Amendments to the Drawings:

REMARKS/ARGUMENTS

FIG 2

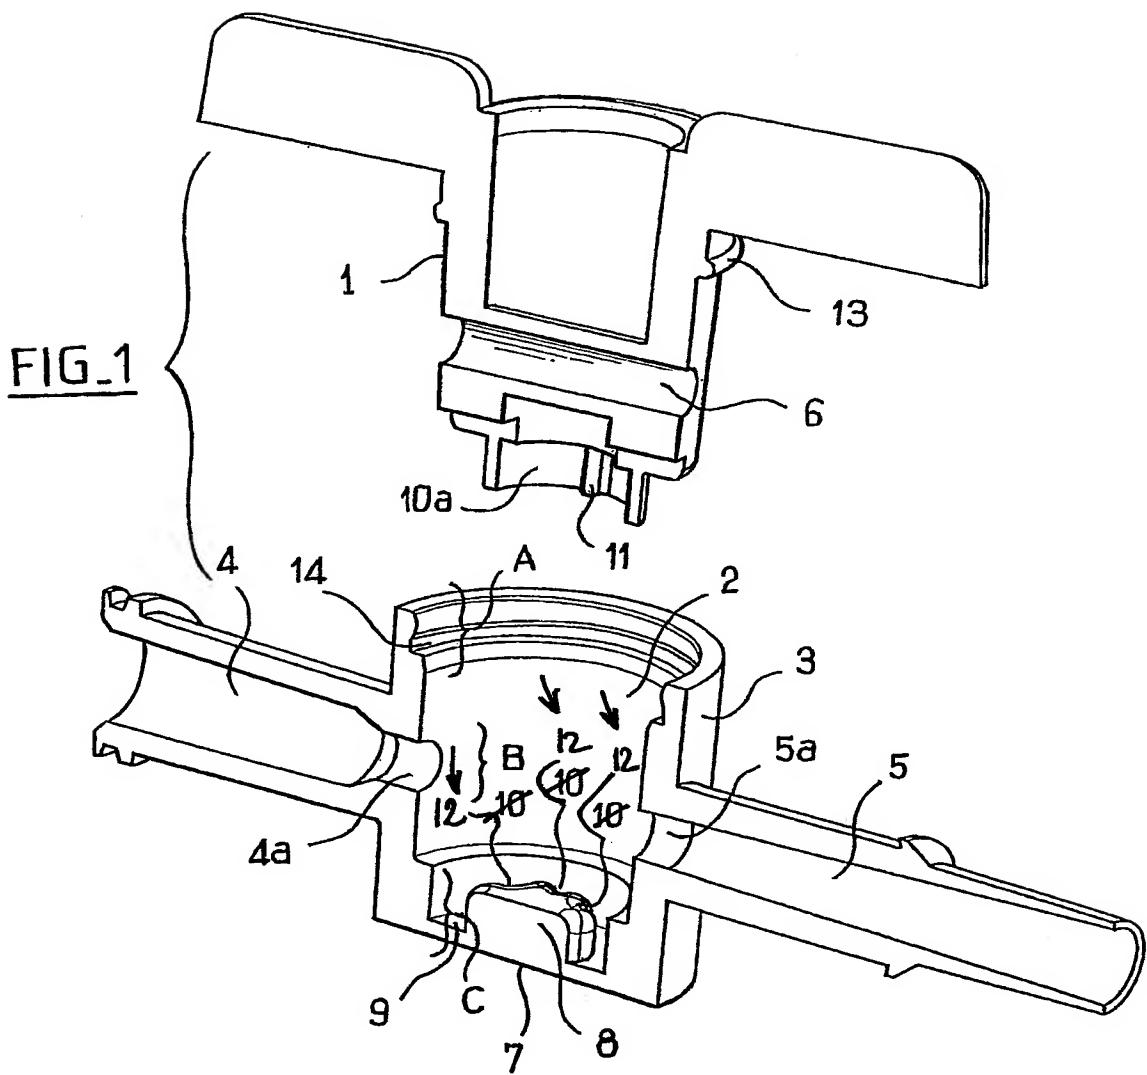
The attached sheets of drawings includes changes to Figs. 1 and 2. These sheets, which include Figs. 1 and 2, replace the original sheets including Figs. 1 and 2. In Figures 1 and 2, reference numerals 10 have been changed to 12.

Objection was made to the drawings due to the use of reference numerals 10 and 12 to designate notches on the raised element 8. New drawings are submitted herewith in which reference numeral 10 has been changed to 12.
